Summary of communications for **CSC-2601: Model Z SlimRack+ Wire Securement**

Customer Satisfaction Campaign CSC-2601

SLIMRACK+ MOTOR WIRE INSPECTION AND REPAIR		4 3 2 1 0 3 Difficulty Level	
CSC:	CSC-2601 Model Z SlimRack+ Motor Wire Inspection and Repair				
PRODUCT:	Model Z	VIN Range:	008896 - 012219 012367 - 012414	REVISION:	REV-A
DATE:	April 22, 2026	LABOR RATE:	Confirm at Pre-Auth Stage

Figure 4

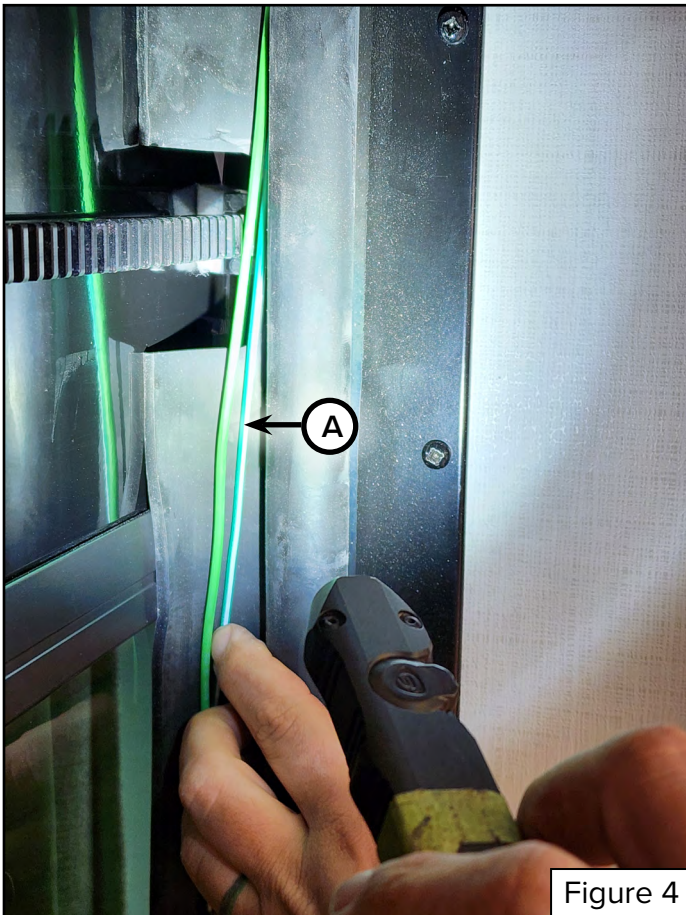
5. If the wires are visible outside of the bulb seal (Figure 4A), and undamaged, they will need to be tucked back into the bulb seal (Figure 5A). If the wires are damaged at all, refer the to repair section below.
6. If there is no screw-mounted zip tie securing the wire at the top of the column as shown in Figure 3A, that will need to be added as well. Be sure to trim any excess zip tie material after securing.

3. The motor wires should be secured behind the bulb seal (Figure 2A) on the face of the column (Figure 2B).
4. If the wires are secured behind the bulb seal and also have a screw mounted zip tie securing the wire at the top of the column (Figure 3A), the unit is safe to continue using as is and no further action is required.
